ADDENDUM #3

PROJECT: Northern Moraine Wastewater Reclamation District
Lakemoor Lift Stations Modifications

PROJECT NUMBER: NMW-070

Project No.:	NMW070
File Name:	LS3.2.dgn
Plot Date:	9/19/2022
Scale:	1/2" = 1'-0"
Sheet Number	LS3.2

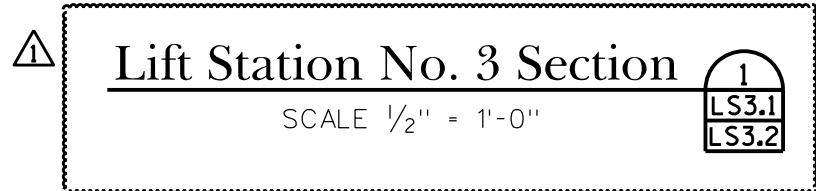
-
1. Sheet C0.2 has been modified to include quantities of the proposed Merrimac stone on the landscaping plans.
 2. Sheets LS3.2 and LS4.2 have been modified to remove the proposed pump replacements.
 3. LS6.2 has been modified to show the proposed discharge pipes to be replaced as flanged DIP and an EBAA 2100 Megaflange joint at the existing steel pipe in the wet well.
